1.2 LATE ITEM - 271 Bridge Road, 208, 224, 228, 230 and 238 Church Street, 42 and 46 Cameron Street and 25 and 37 - 39 Bank Street, Richmond - PLN11/0834.02 - Consent Order to amendments to conditions of Planning Permit PLN11/0834

Trim Record Number: D19/76309

- Proposal:** Amendment to the endorsed plans and permit conditions of PLN11/0834 including:
- Incorporating the approved development for 42 Cameron Street (PLN14/0314) into the permit for the main site
 - Amendments to the plans to including modifications to the internal uses and layouts and exterior changes in height and design.
 - Increase in car parking, motorcycle parking and bike parking.
- Existing use:** Richmond Plaza Shopping Centre and Residential Apartment building.
- Applicant:** Coles Group Property Development Pty Ltd – C/- SJB Planning Pty Ltd
- Zoning / Overlays:** Commercial 1 Zone, General Residential Zone (Schedule 1 & 2), Design and Development Overlay (Schedule 2 and 21), Heritage Overlay (Schedule 310) and Public Acquisition Overlay.
- Date of Application:** 26 April 2018
- Application Number:** PLN11/0834.02

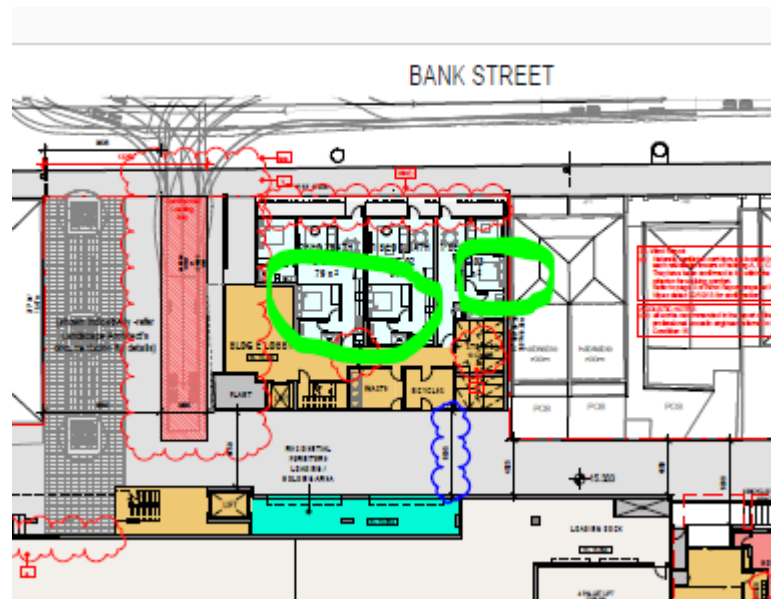
15. Reasons outlined for challenging this condition were based on commentary that the standard of the plans aligned with those already approved. Officers did not agree with this proposition and the concern with this condition has been narrowed by the permit applicant to relate to issues with the layouts of Building 'E'.

16. The apartment layouts of Building 'E' include dwellings which included borrowed light apartments (see excerpt from Ground Floor Plan).

17. Approval has already been granted for some borrowed light apartments and the intent of the condition was not to delete these but to ensure that the plans had an appropriate level of detail to ensure internal amenity of the dwellings.

'Plans and elevations to clearly show location of doors and windows for both commercial and residential uses and all habitable rooms having openable windows **(with the exception of dwellings within Building E which must continue to have access to natural light by way of an openable window, sliding door or similar)**'.
